**Sent:** 25/03/2019 7:02:07 PM  
**Subject:** RE: Modification to DA2018/1432 - Mod2019-0118  
**Attachments:** Objections to MOD2019-0118.pdf;

| <b>Objections to MOD2019-0118, 60 Riverview Parade, North Manly</b> |

The purpose of this letter is to raise an objection to certain elements of the proposed building development intended for 60 Riverview Parade, North Manly as detailed in Mod2019-0118.

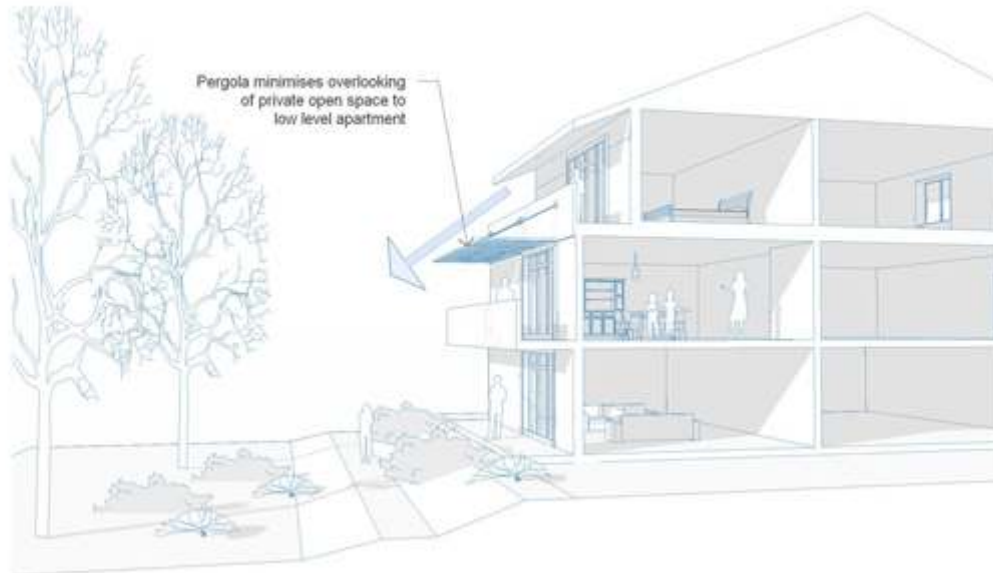
I have included a copied image of one of the examples found on the WDCP website. I would note that this example has a strong correlation to the situation that exists between 58 and 60 Riverview Parade.

Image 1

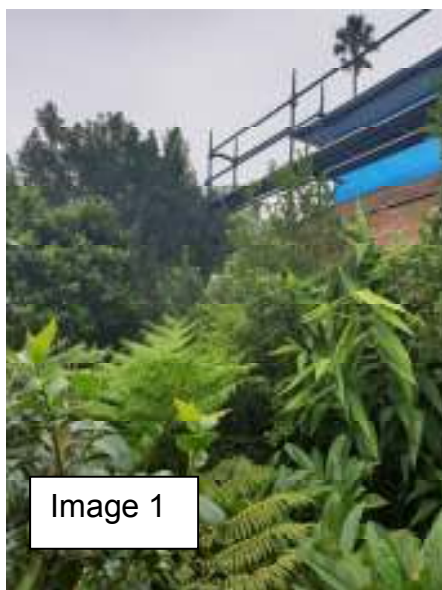
- I would argue that the situation does create additional privacy impacts.
- The modification and removal of the existing windows and terrace does improve my privacy situation.
- *The addition of a new balcony approximately 0.9 meters from the property line directly overlooks my bedrooms and front yard. Image 1 below is from my bedroom 3 window, the balcony can be easily seen to the left of the blue wall wrap. From the balcony an occupant of number 60 can look over the plants directly into bedroom 3.*
- The intervening vegetation mentioned is limited in height (so not screening) and is deciduous, meaning a loss of privacy over the cooler months. I have included images below to illustrate.

- The balcony looks directly into bedroom 3, refer image 1.
- The front garden was effectively a private space, despite being in the front set back. The balcony directly overlooks it.

**An acceptable solution to me would consist of one of the screening solutions suggested in D8 Privacy of the WDCP (e.g. a fixed frosted glass panel). I believe that is consistent with the intent of the WDCP.**

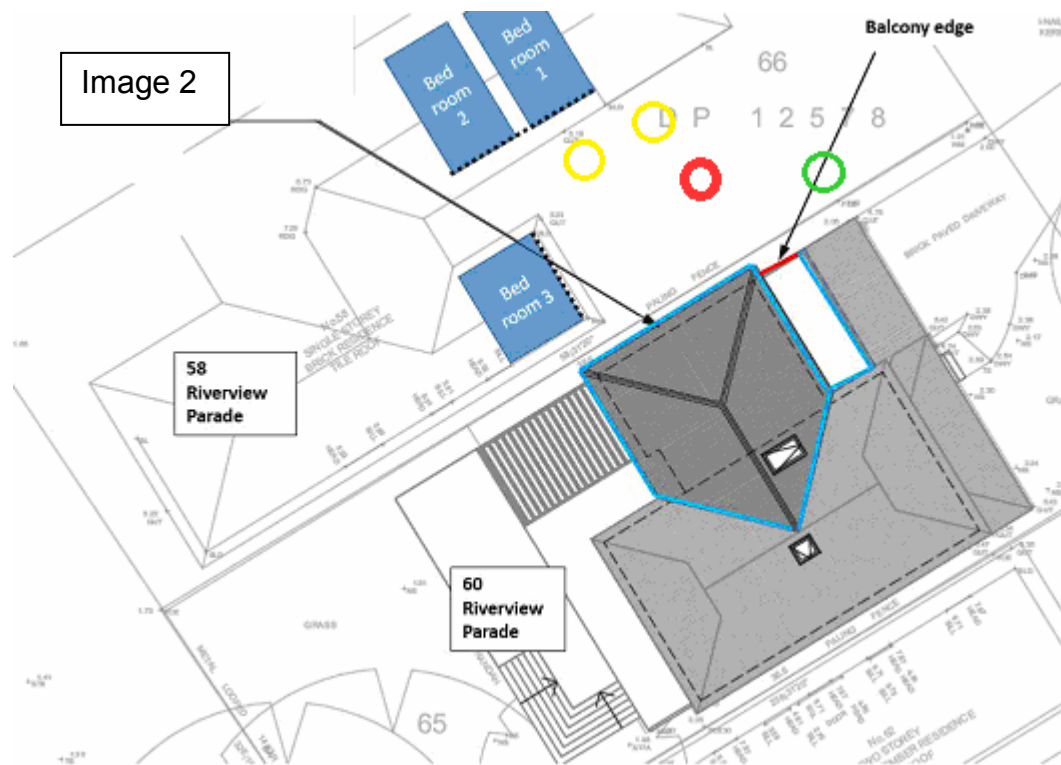
Please refer image 2 below. Image 3 was taken by me whilst standing at the site of the red circle looking towards the balcony (which can be easily seen). Image 4 is the reverse view (from red circle) looking back towards bedrooms 1 and 2. The yellow circles on image 2 indicates the location of these plants referred to in image 4.

*The green circled plants of image 4 will lose their leaves over winter providing no screening at all. The remaining plants are two tree ferns that are not effective as privacy screens.*

- The privacy implications to bedrooms 1 and 2 of street views is effectively zero, refer image 6.
- The tree mentioned in point 1) of the Smith submission does not obstruct any view of the bedrooms. Image 2 and green circled below.
